**FINAL
Environmental Impact Report
for the
Old Oakland Mixed-Use Project**

March, 1988

1 File No. ER ES-11
2 Ref. No. SCH #85090315

FIGURE 3.3-2. EXISTING PUBLIC PARKING FACILITIES USAGE

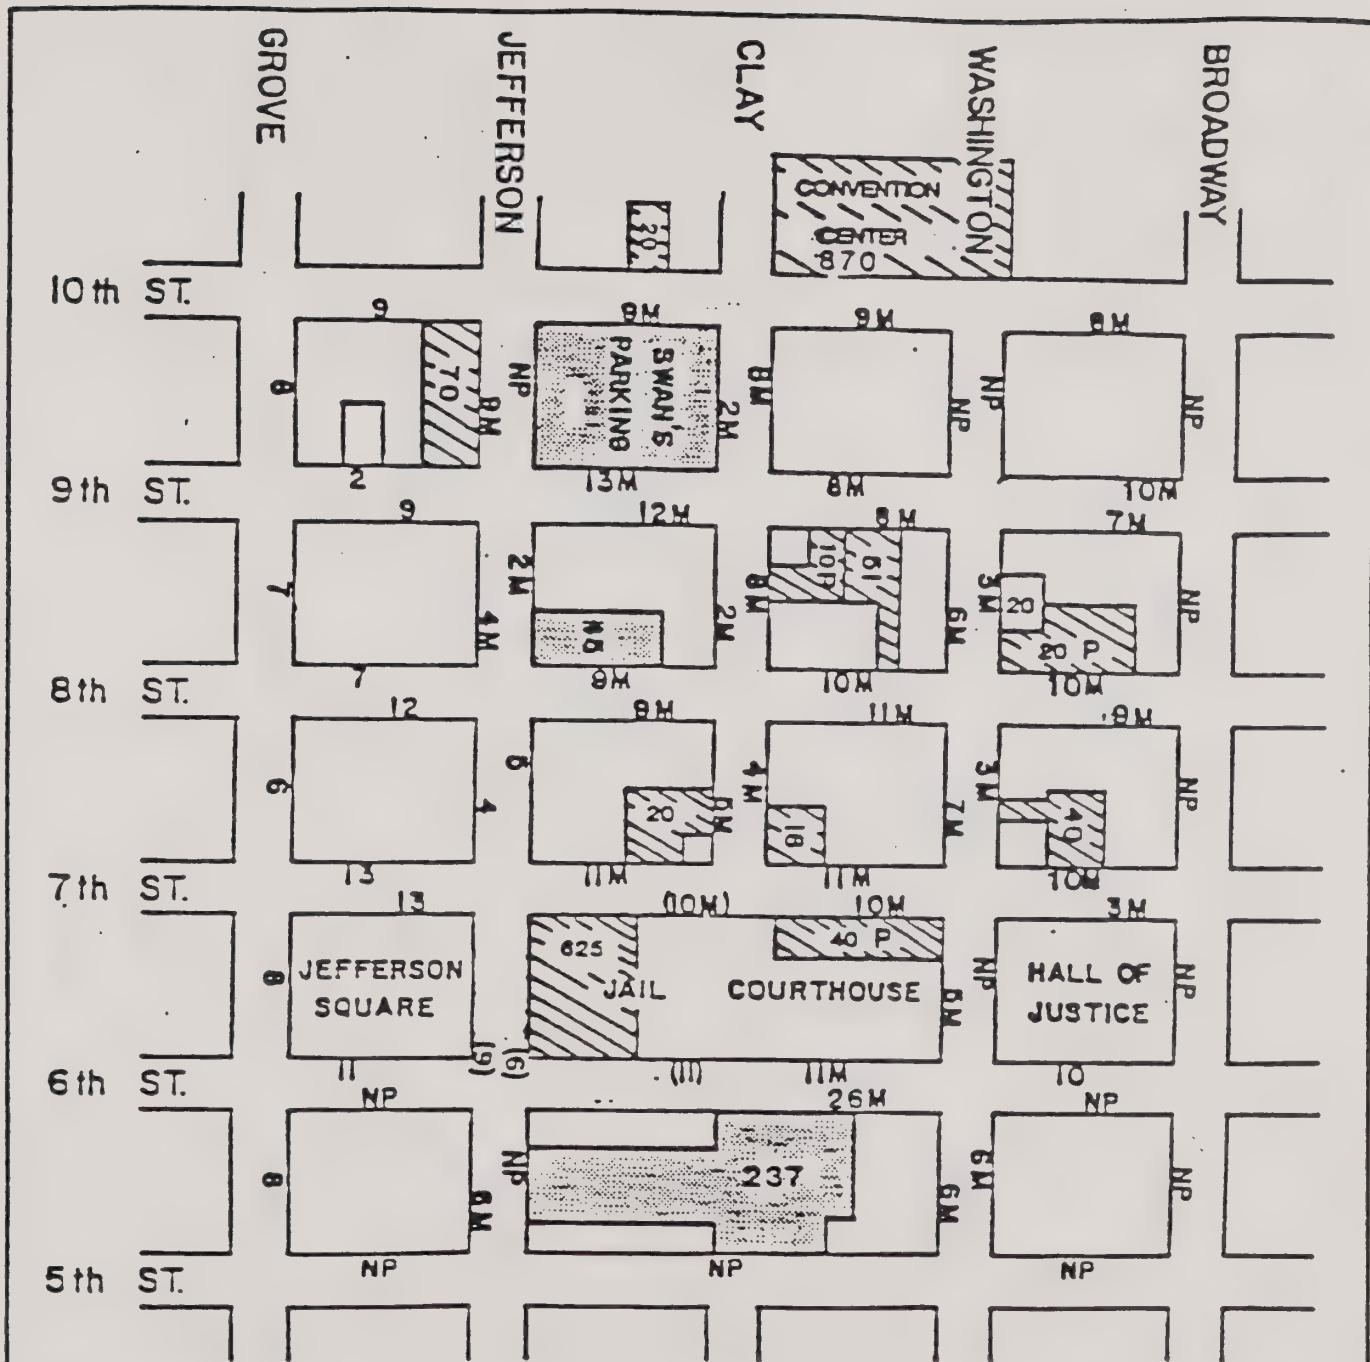
4. Figure 3.3-2 -- Make changes as shown on the attached copy.

Refer to Committee

25 B.4 Existing Parking Facility Usage. The changes shown on Figure 3.3-2
26 in this comment are noted and accepted.
27

FIGURE 3.3-1. INVENTORY OF EXISTING PUBLIC PARKING FACILITIES

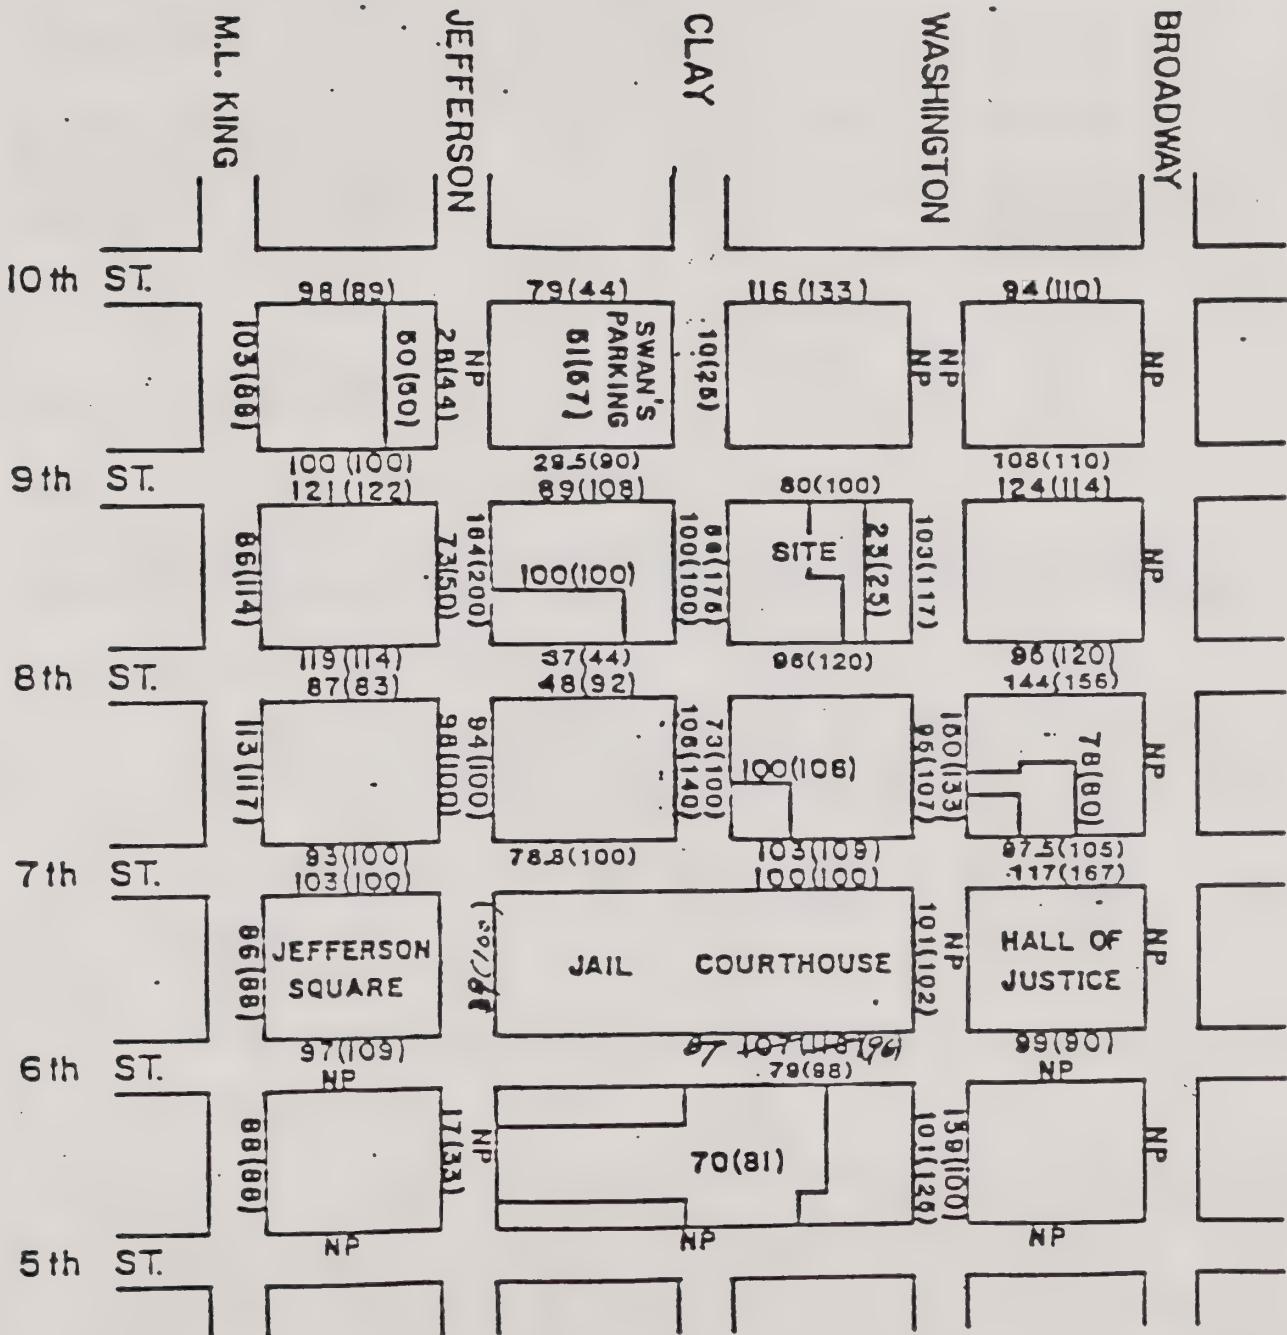
2. Figure 3.3-1 -- The figure should be updated based on the 1986 parking survey conducted by the City. This information is available from the Traffic Engineering Division.

need to
be updated. Refer to comment

19 B.2 Parking Data Update. The RGM Associates update identified on Figure
20 3.3-1 does include data from the City's 1986 parking survey.
21
